SERVICE INSTRUCTION

Introduction of new floats (pair) for ROTAX® Engine Type 912 and 914 (Series)

Introduction of new floats (pair) for ROTAX® engine type 912 and 914 (Series).

Fig. 1
Comparison of floats

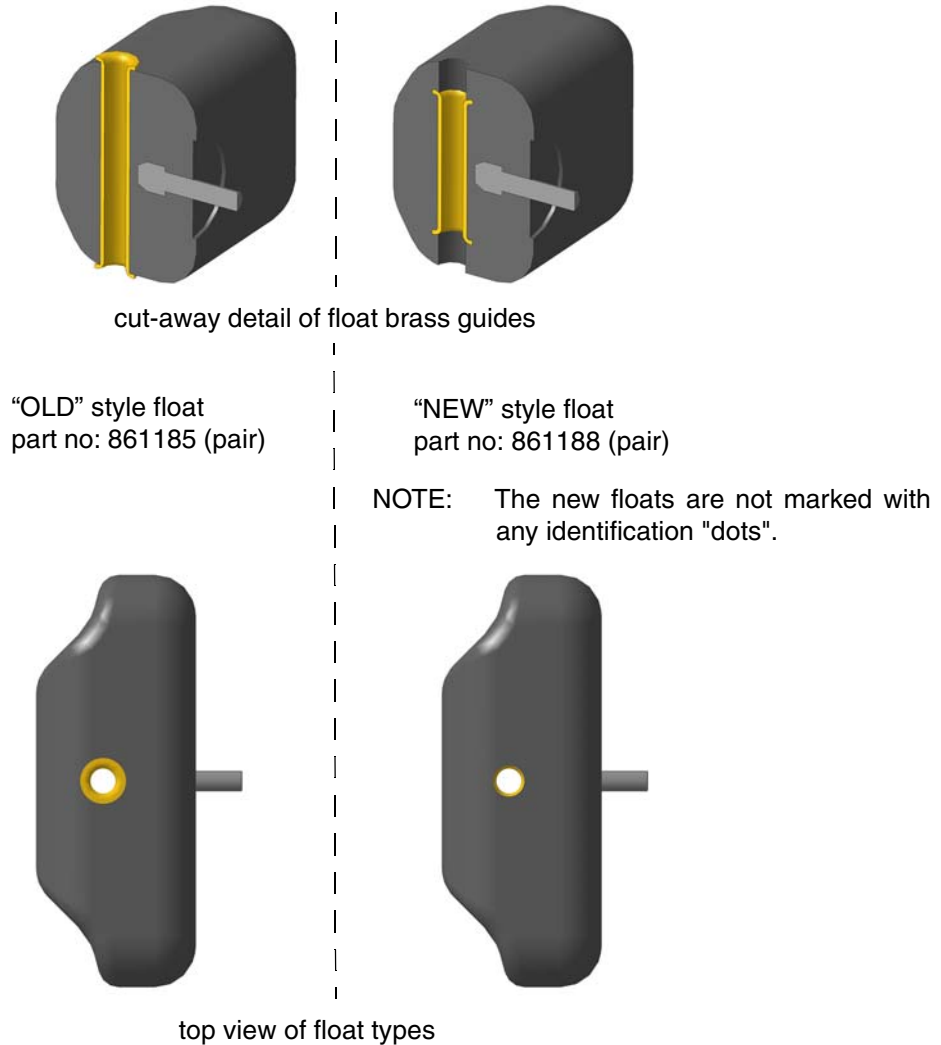
In the course of continuous development and standardization, new floats (pair) ROTAX® part number 861188 have been introduced. These new floats (pair) are manufactured with a higher compaction rate and contain a recessed brass guide. See Fig. 1.

Fig.no.	New p/n	Qty/engine	Description	Old p/n	Application
1	861188	As required	Floats (pair), guided	861185	Engine type 912 and 914 (Series)

As per Maintenance Manual Line (MML) let the floats dry for 1-2 minutes. Only weigh dry floats. Due to their higher compaction rate, the dry weight of the new floats (pair) part no. 861188 may be higher than the previous floats. But in no case the max. weight (of both floats together) is allowed to exceed 7 grams and so still applies. See relevant Maintenance Manual Line Chapter 12-20-00.
